Whitworth Street Planning Comparison

Since planning approval in 2016 the site has been purchased by Vision Manchester Limited. The client has engaged a full design team and RussellWBHO to update the detail design to the required regulations, agree a building contract and construct the development. Through this process a number of design changes are being proposed.

This updated document is being presented to Manchester City Council Planning Department to illustrate and explain the nature and extent of the proposed changes and to seek the Council's formal approval through the necessary planning process.

3.24 Proposed Elevation South

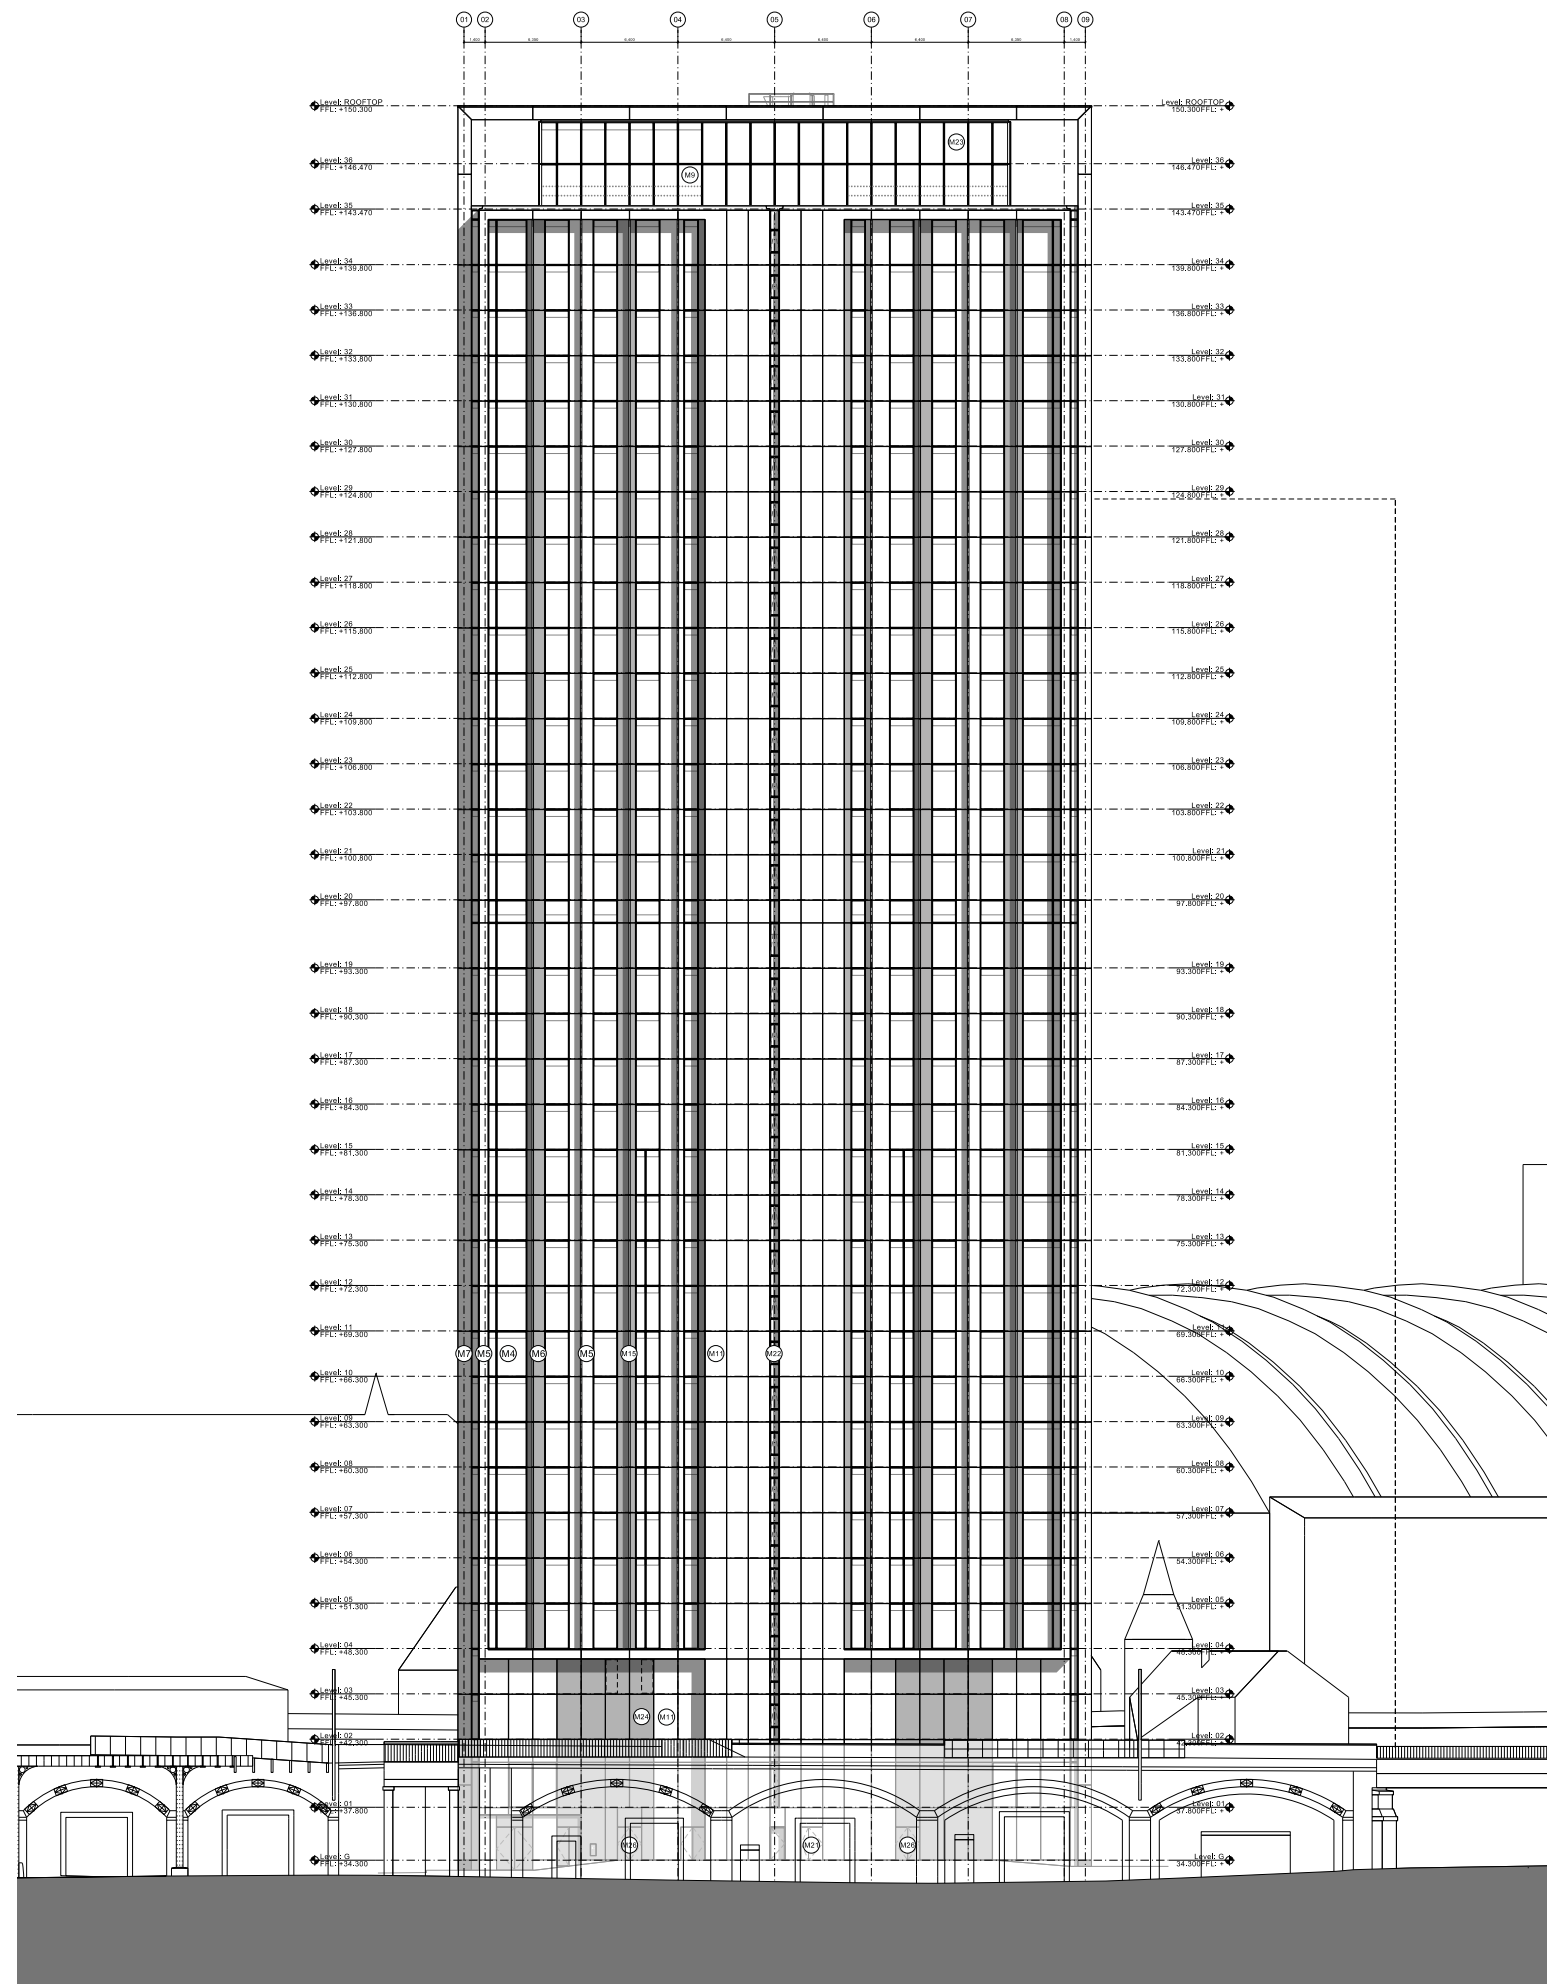
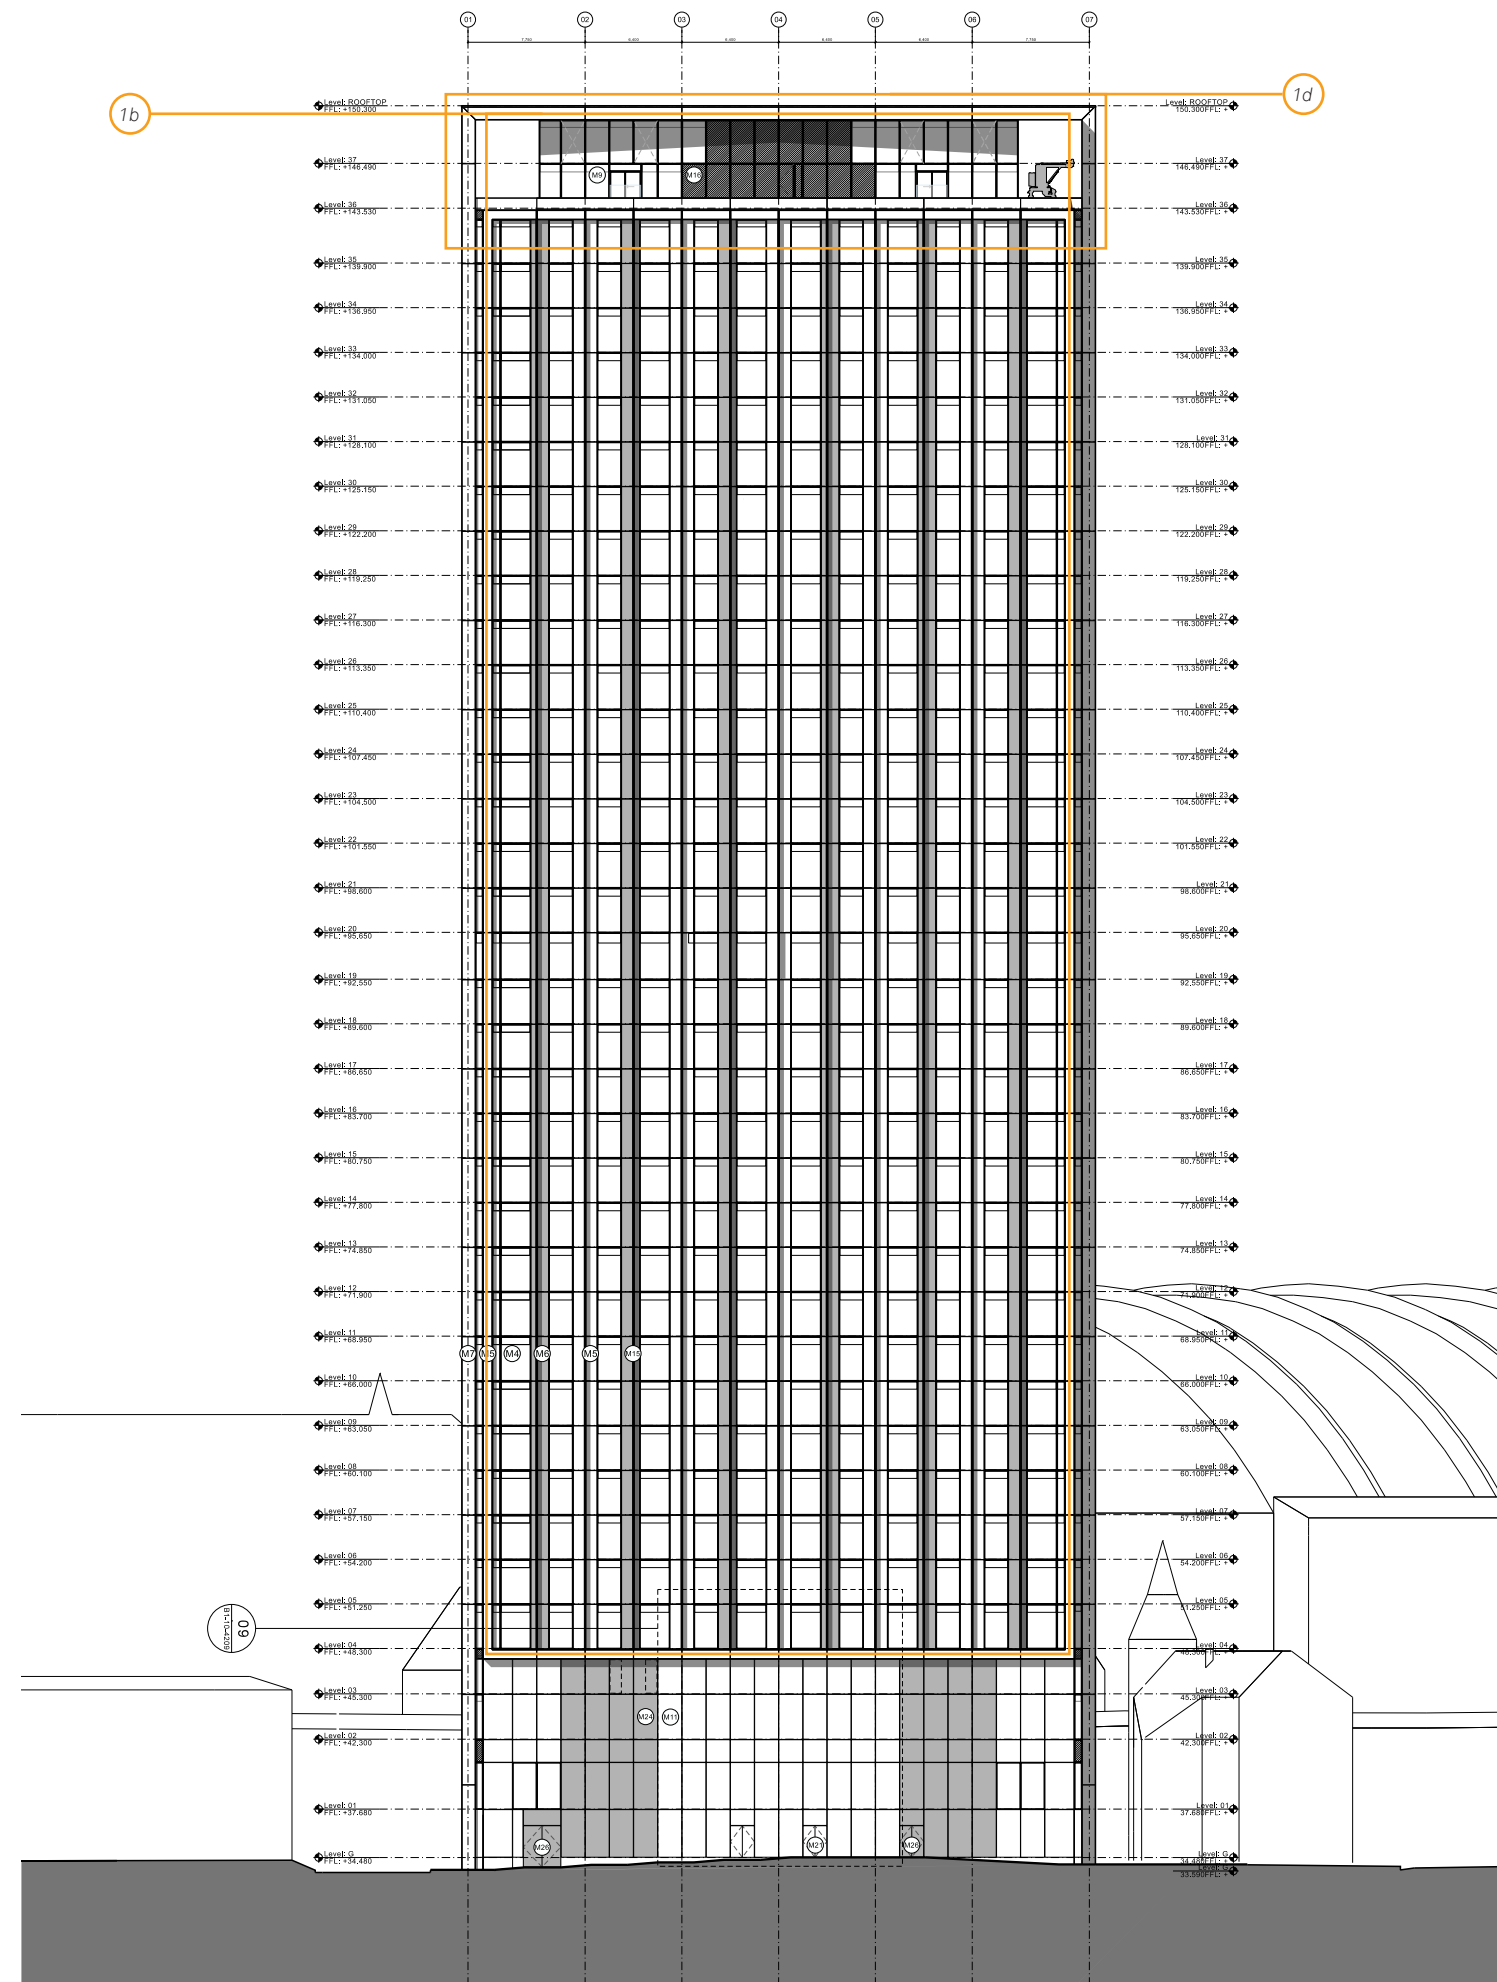
- 1a - Core Repositioned
- 1b - Main body of south facade to match north facade
- 1c - Entrance relocation
- 1d - Form of roof pavilion
- 1e - Apartment & amenity layouts
- 1f - Inclusion of commercial unit & dedicated entrance
- 2a - Reduced floor to floor heights
- 2b - Additional floor
- 2c - 2 no. Guest Beds & 2 no. 1 Bed become 2 no. 2 Bed & 2 no. 3 Bed
- 3 - South 'picture frame' reveal depth reduced by 600mm
